CITY OF MOUNTAIN VIEW

ENVIRONMENTAL PLANNING COMMISSION STAFF REPORT WEDNESDAY, NOVEMBER 18, 2020

5.1 Study Session to Discuss a New 182,000 Square Foot Office and Retail Development at 365 San Antonio Road

Figure 9: Southern Elevation

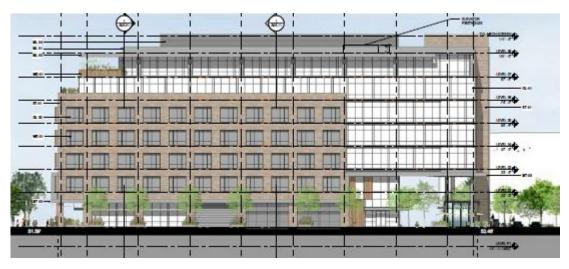
Southern Facade: The southern facade is designed as "back of house" with utility rooms and loading areas. This location is acceptable as it aligns with similar areas in the adjacent Phase II office building, and Silicon Way is the least prominent project frontage. However, staff still anticipates the area will be highly used by pedestrians, and further efforts should be made to make the environment comfortable. Staff and the DRC recommend the applicant differentiate the base of the project from the upper floors by stepping in the first or first two floors to create a wider pedestrian walk zone through a partial pedestrian arcade along at least a portion of the frontage. Staff also recommends more high-quality materials be used in the utility areas to help make it a more inviting pedestrian environment.
